#### **Addendum 109 – Regulation No. 110**

#### **Revision 3 - Amendment 2**

Supplement 3 to the 01 series of amendments – Date of entry into force: 8 October 2015

#### **Uniform provisions concerning the approval of:**

Figure 1-1  
Flow scheme for CNG and/or LNG components classification

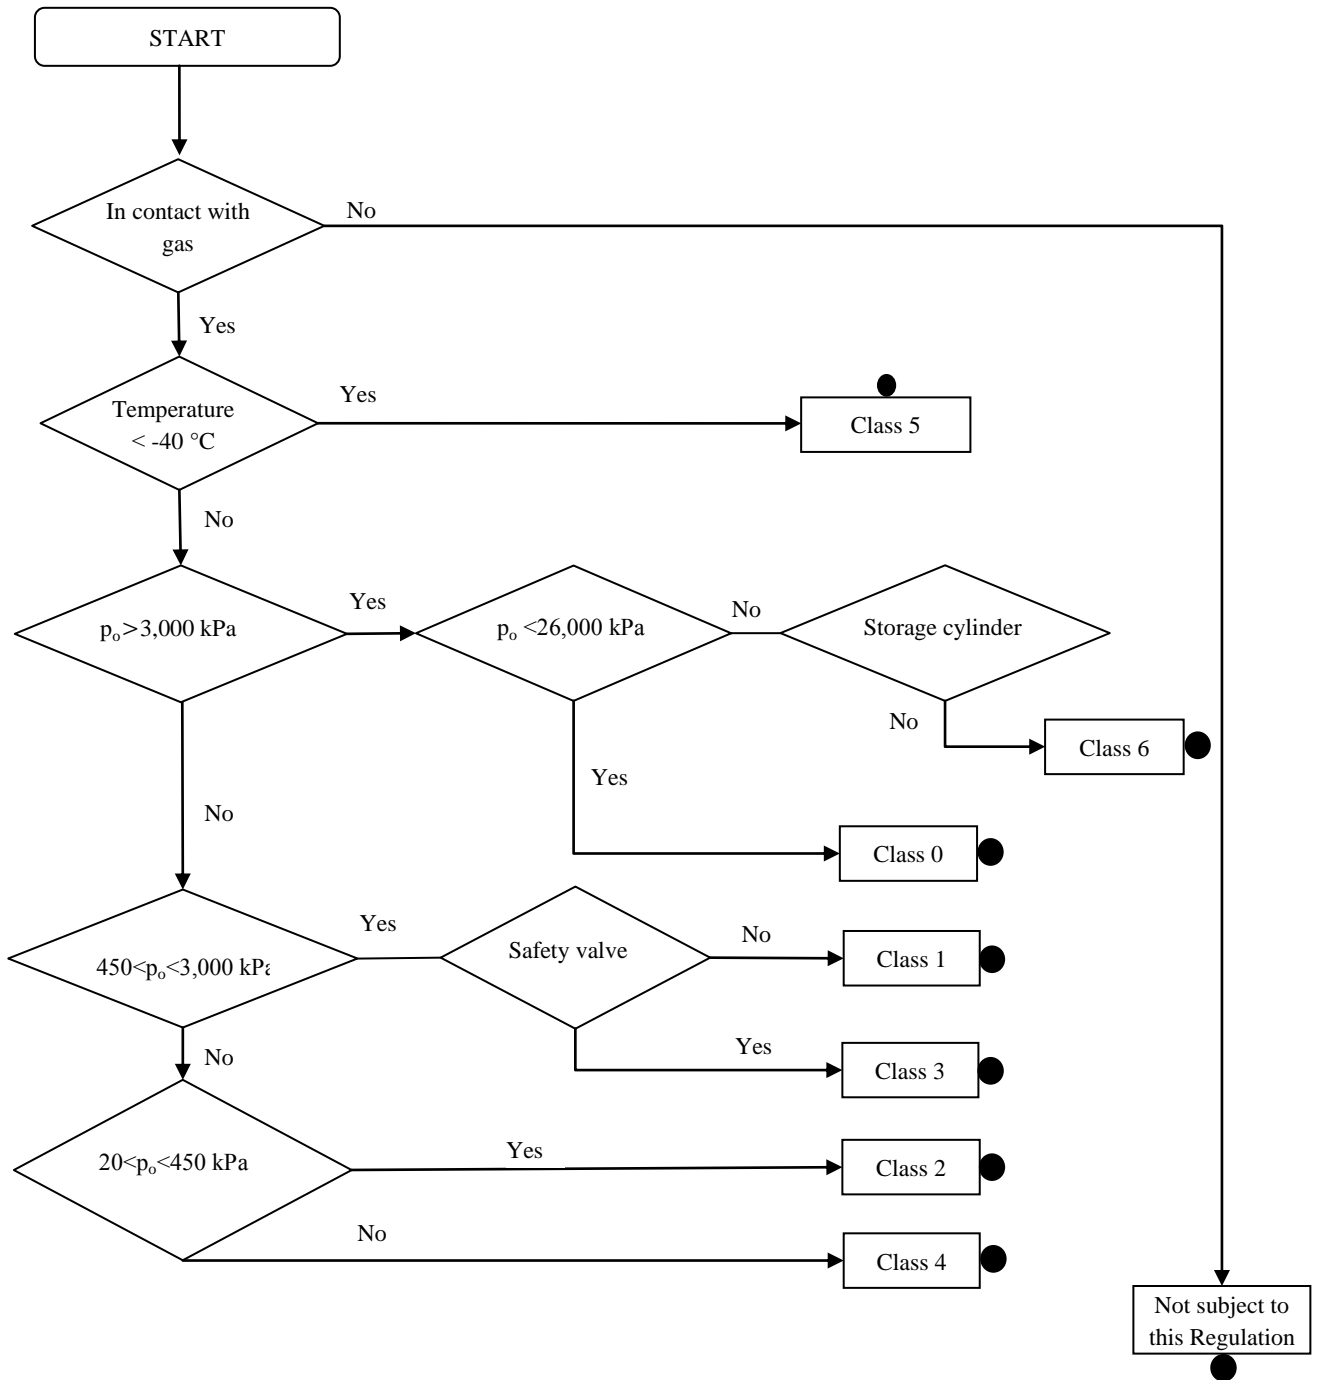
*Paragraph 3., insert a new class and amend Figure 1-1 and Figure 1-2, to read:*

"3. Classification of components

Class 6 High pressure parts including tubes and fittings containing CNG, excluding CNG containers, at a pressure higher than 26 MPa.
